CITY COUNCIL STAFF REPORT - SUMMATION
Sweetgrass 1st Filing Final Plat

CASE NUMBER: UDC-18-00105-01

PROJECT: Sweetgrass 1st Filing Final Plat

Figure 3: Proposed Sweetgrass 1st Filing Final Plat
Green lines indicate City Greenway routes.
Source: Landmark Engineering LTD

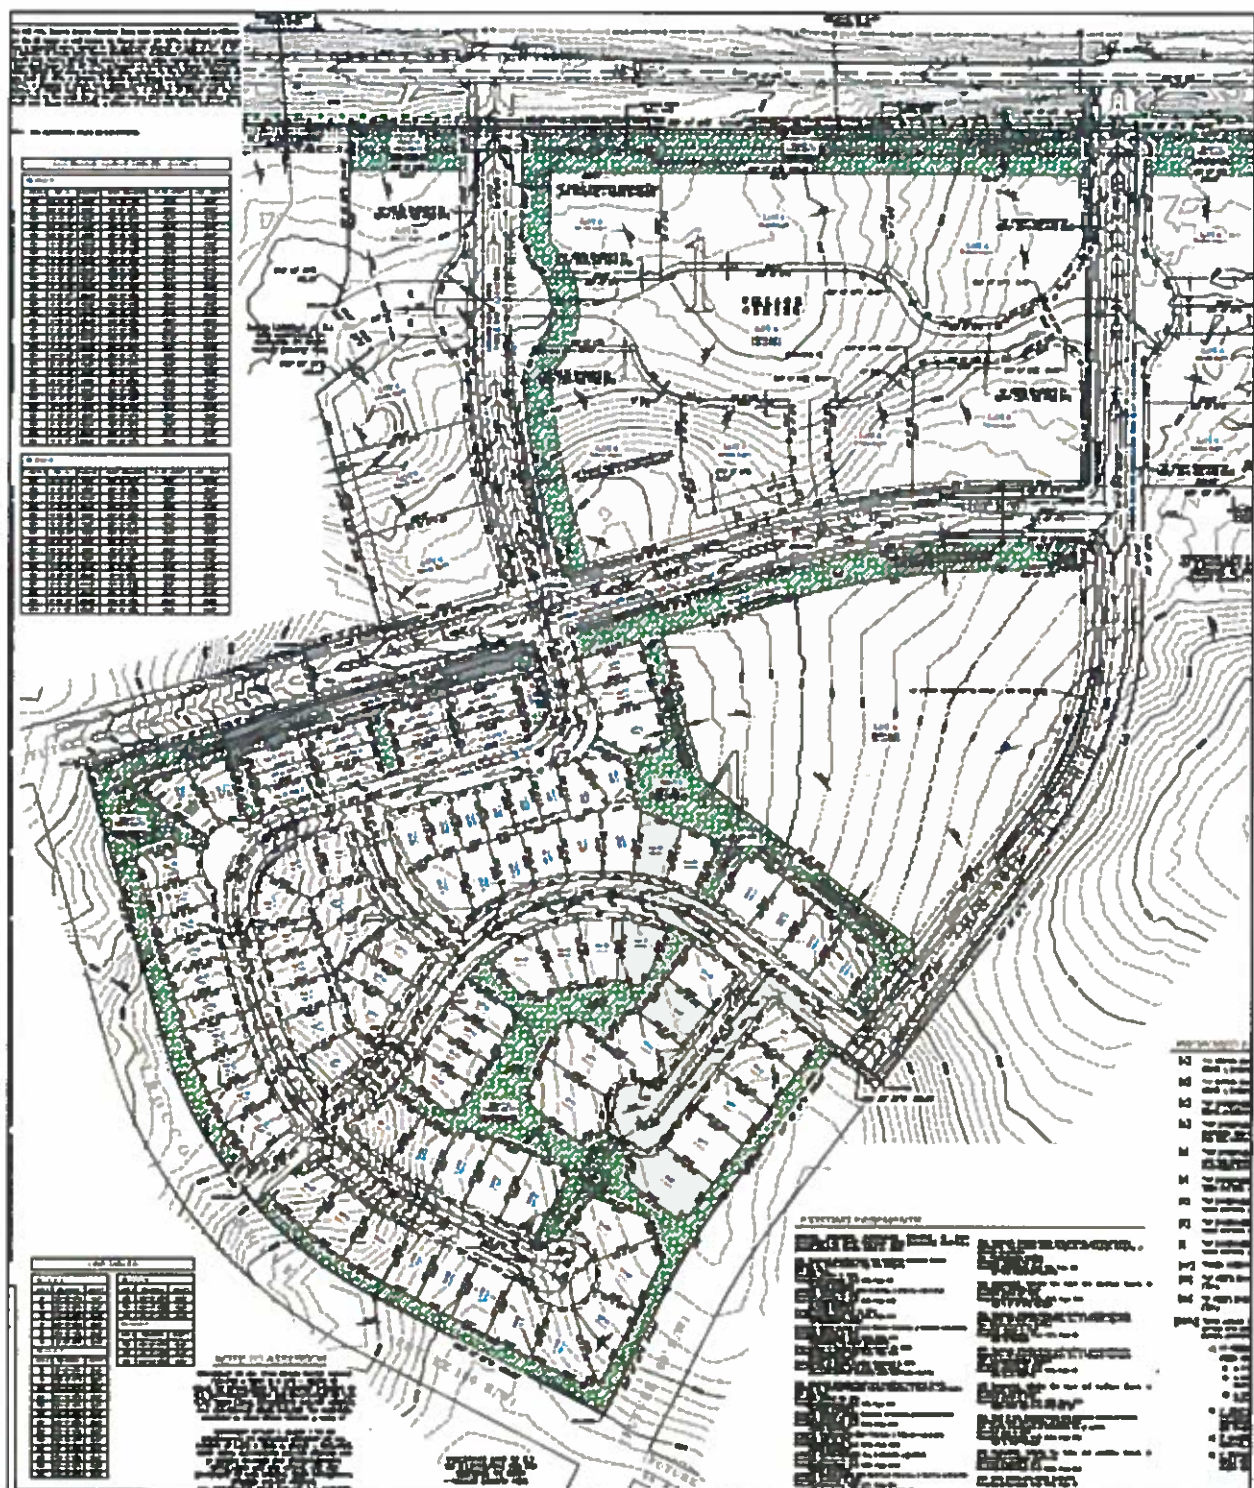
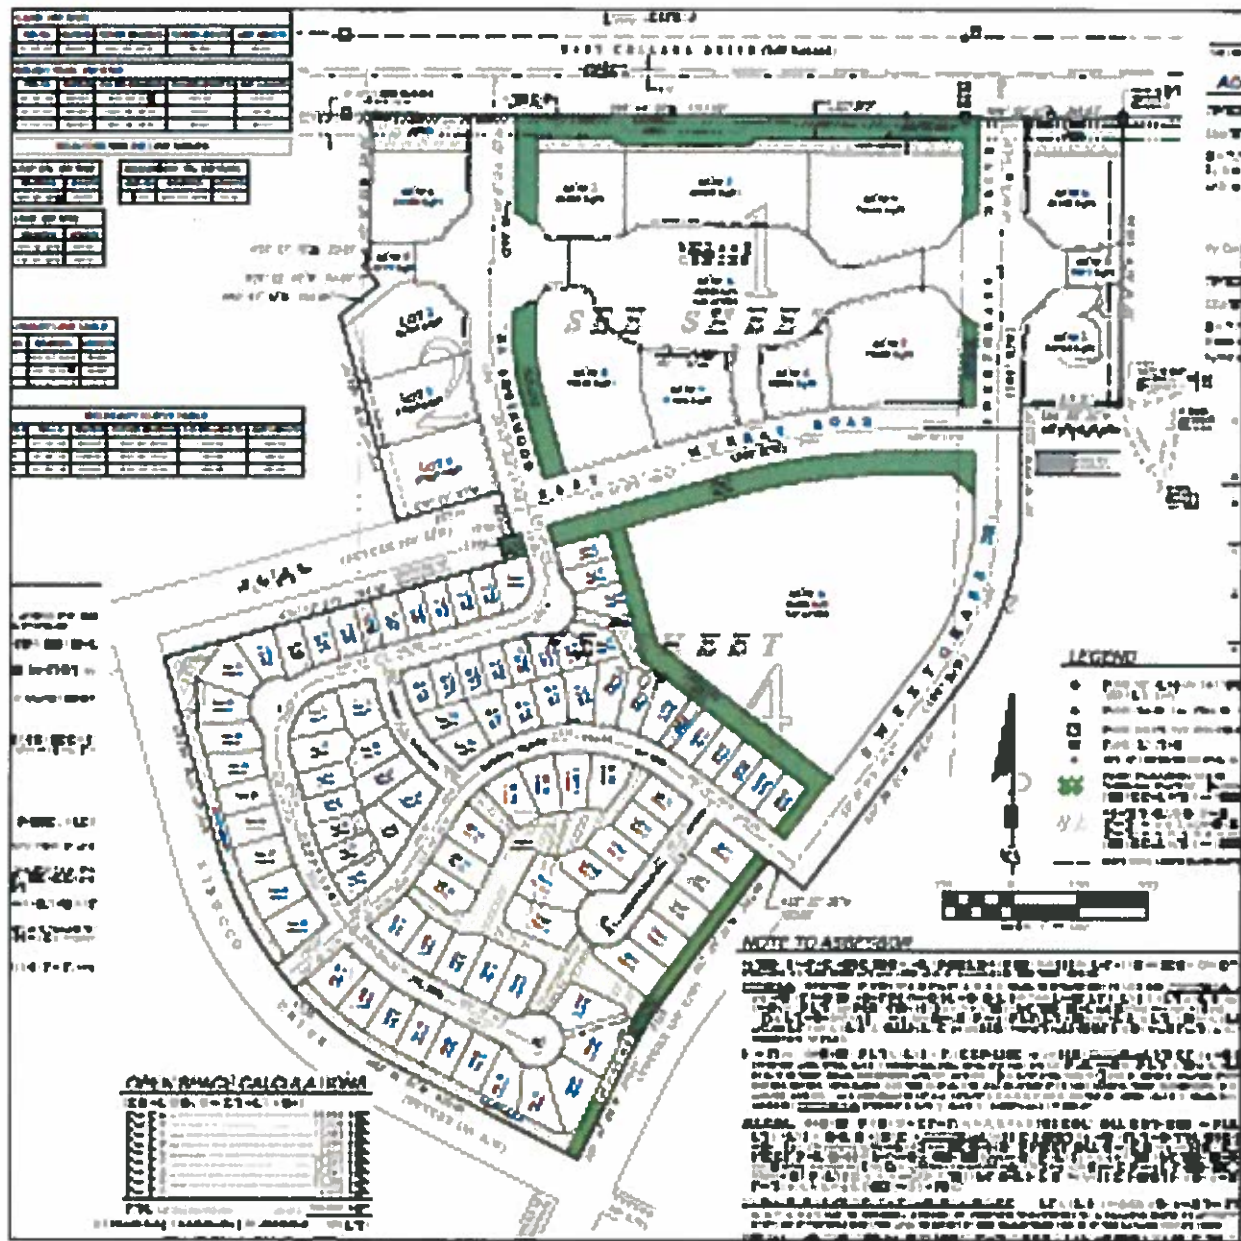
The Final Plat varies from the adopted Preliminary Plat in the following ways:

1. The northern "Village Center" features two lots, Lot 5 of Block 2 and Lot 3 of Block 3, which appear as stub-out roads to future development of lands to the west and east, respectively on the Preliminary Plat (PP). However, in this FP, these lots are to be "*reserved for future r/w / accessway(s) to remain under current ownership and granted hereon as ingress, egress, utility & drainage easements.*" Therefore, those two lots are private access easements. If, in the future, these two lots are to be granted to the City for public rights-of-way connecting to future connecting rights-of-way, this FP would need to be re-platted to affect this dedication to the City.

2. The townhome lots in Block 5 of the PP are shown as single-family lots on the FP.
3. One lot (Lot 13) in Block 6 of the PP is shown as two lots (Lots 13 and 14) in the FP.

4. Four lots in Block 7 (Lots 15-18) of the PP are shown as three lots (Lots 16-18) in the FP.
5. Four lots in Block 4 (Lots 21-24) of the PP are shown as five lots (Lots 22-26) in the FP.

6. Lots 6, 7 and 8 of the PP are reconfigured and the result is a Lot 6, 7 and 445 in the FP without explanation as to why one lot, Lot 445, is out of sequence.

7. Overall, lot shapes and sizes have changed.
8. Private and public greenway routes and sizes have changed.
9. Two street names have switched locations: Arrowleaf and Goodnight.

Staff Evaluation. **Complies.** These changes are deemed minor and the FP is deemed in substantial compliance with the approved PP.

Figure 8: Greenway routes in Block 1

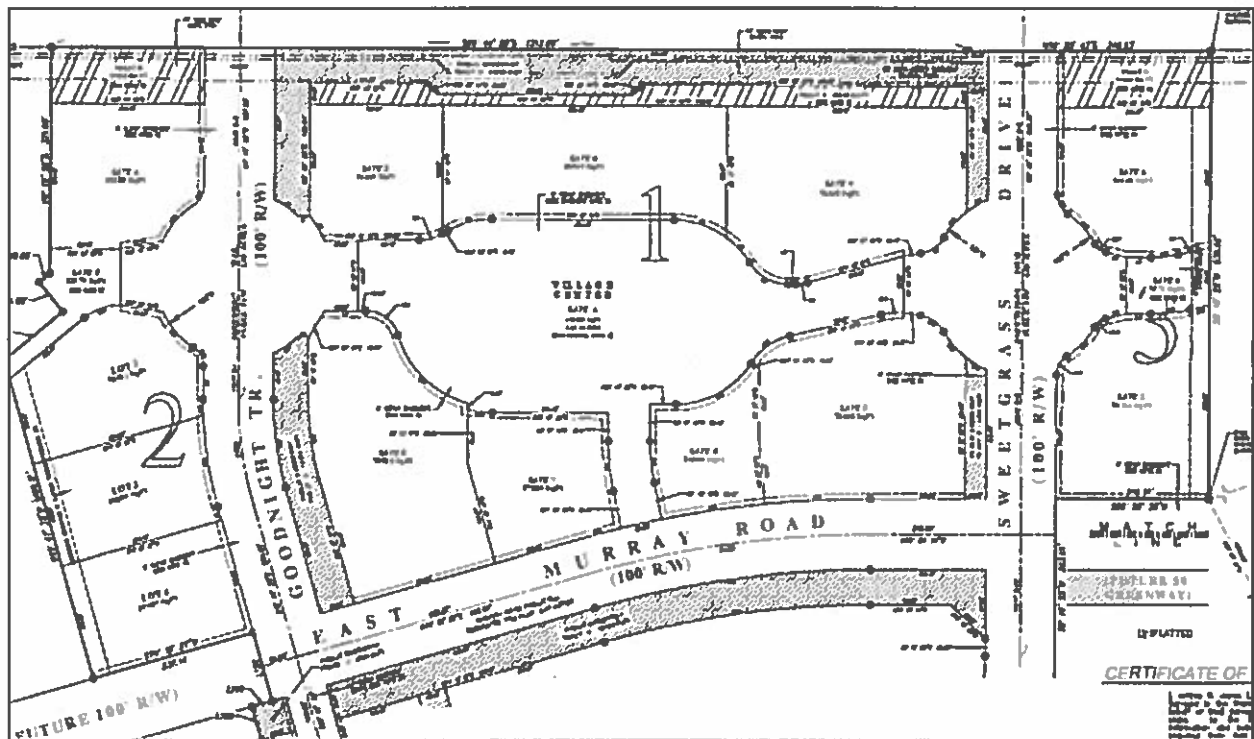
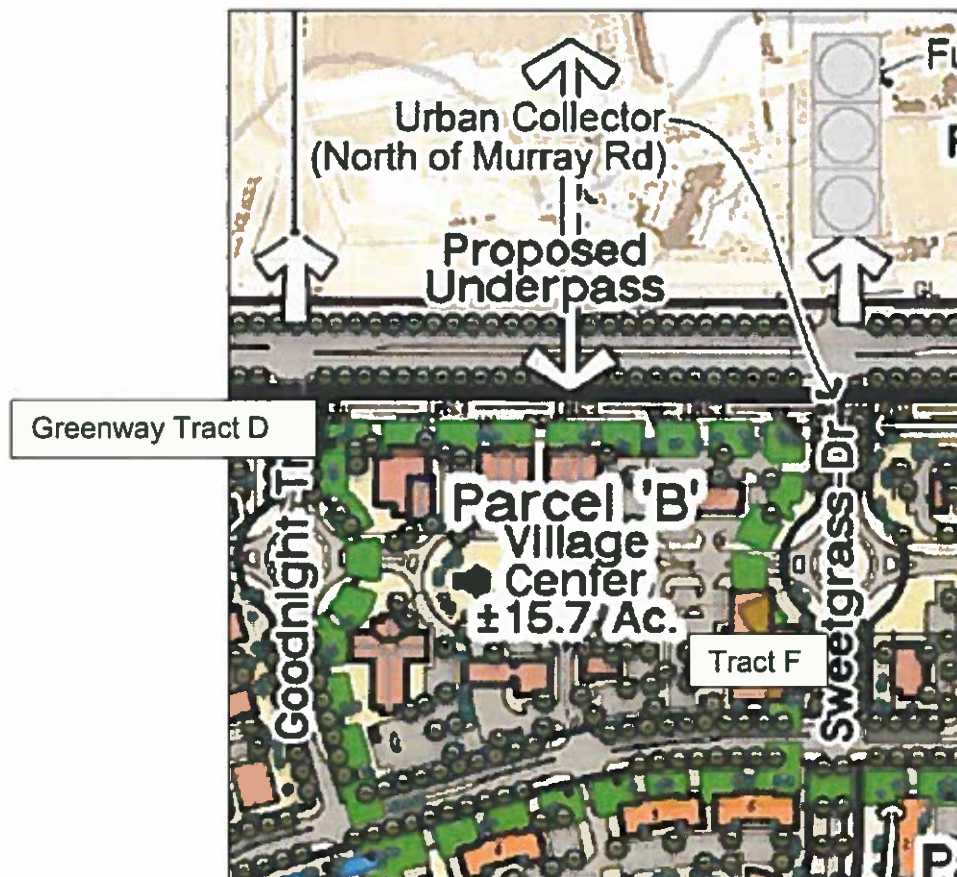
There was concern by the Greenway Program staff with accepting the eastern half of Greenway Tract D and its connecting Greenway Tract F shown above in Figure 8. The LCCC tunnel under College Drive is an important feature which would safely link the campus to Sweetgrass commercial, meeting, event and residential activity serving LCCC students and employees. It is the intent of the City to provide a greenway link from the tunnel entrance TO the Sweetgrass lands and then to the internal greenway and private trails within the community per the extensive trail system therein (see Figure 9 below).

Unfortunately, the tunnel “daylights” about 12 to 15-feet below grade of the Sweetgrass Block 1 land and the eastern route to Sweetgrass Drive is about 700-feet distant. To build this eastern route to Greenway Program and ADA standards, a long ramp would be needed to connect to the Sweetgrass Drive route and steps may be needed for pedestrian convenience (to avoid the long ramp needed for wheelchair access and bicycle convenience). The Applicant would bear the cost of installing the long ramp and retaining walls for proper slope on the eastern segment to Sweetgrass Drive. However, the City would maintain the ramp and steps which was a concern due to the extra labor in snow removal for steps which was believed to be costly and greater than the City believes the Greenway Program can afford.

This eastern segment of Tract D connects to a greenway segment on the western side of Sweetgrass Drive which then connects to the south side of East Murray Road. The City’s Community Recreation and Events Department would be responsible for maintenance of the greenways. Their staff notes that the eastern segment of Tract D and Tract F (see Figure 8) is redundant in that the western segment of Tract D leads to the greenway Tract E along the east side of Goodnight Trail which, in turn, leads to the south side of the East Murray Road greenway. The elevation differential for the western segment of Tract D from the tunnel to Goodnight Trail is much less and would not need a long ramp and stairs and, therefore, the costs of maintenance of a Greenway and ADA-compliant trail would be more affordable.

After the Planning Commission review of the plat on April 2nd, on May 16th City staff met with Applicant representatives to explain City concerns about maintenance of the ramps and steps of the eastern route from the LCCC tunnel. In this meeting, after considerable discussion, City staff agreed to accept both the east and west greenway route from the LCCC tunnel for operation and maintenance after the Applicant built these segments and conveyed it to the City for inclusion into the greenway system. It was assumed by City staff that the greenway segments shown on the plat would be built by the Applicant or developers to the City's greenway standards and then conveyed to the City; the City would not be building the greenways within the Sweetgrass development.

Figure 9: Murray Road Greenway segment above Block 4, Lot 1.

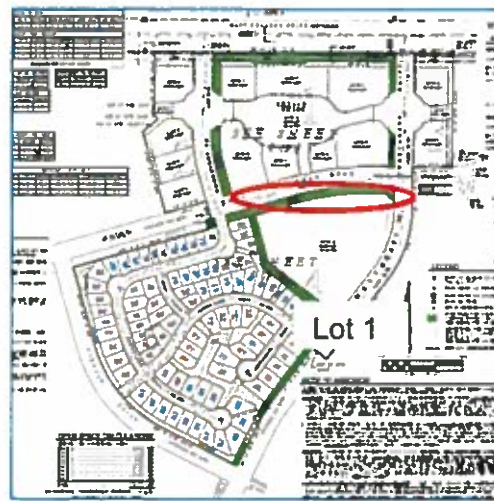
It is also noted that the Applicant may seek to delay building the Murray Road segment until the abutting 7-acre Block 4, Lot 1 is developed. The Applicant would build the greenway segment from Goodnight Trail across Murray Road to the segment along the west boundary of Lot 1 to another Sweetgrass Drive segment (see Figure 9 below). There is concern that the eastern greenway segment from the LCCC tunnel to Sweetgrass Drive and south to Murray Road would terminate without a link to the greenway segment along the west boundary of that Lot 1 and along the east boundary of Lot 1 to Sweetgrass Drive. Pedestrian, wheelchair and bicycle travel would have to take place on sidewalks.

Figure 9: City Greenway routes shown in green on the Master Trails Plan Map.
Source: Landmark Engineering LTD

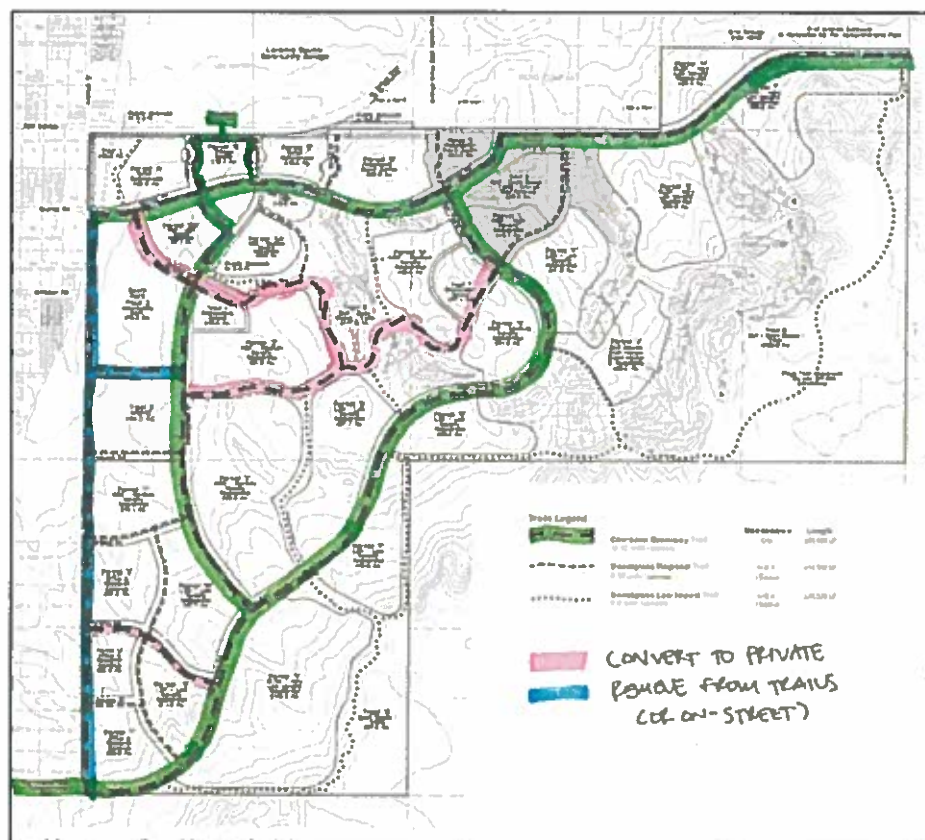
2.The MPO feels agrees R. Zita and T. Moore's previous comments that the approved plan with only the green marked trails are what the City is willing to maintain; the many other trails indicated as public are beyond that threshold. [See Figure 9 as the revised Sheet 6 of the PUD Master Trails Plan.]

In the same May 16, 2018 meeting, the Applicant agreed to revise the Planned Unit Development (PUD) Master Trails Plan Map to reflect the City's recommended reduced greenway routes through the Sweetgrass development as shown in green color on Figure 9.
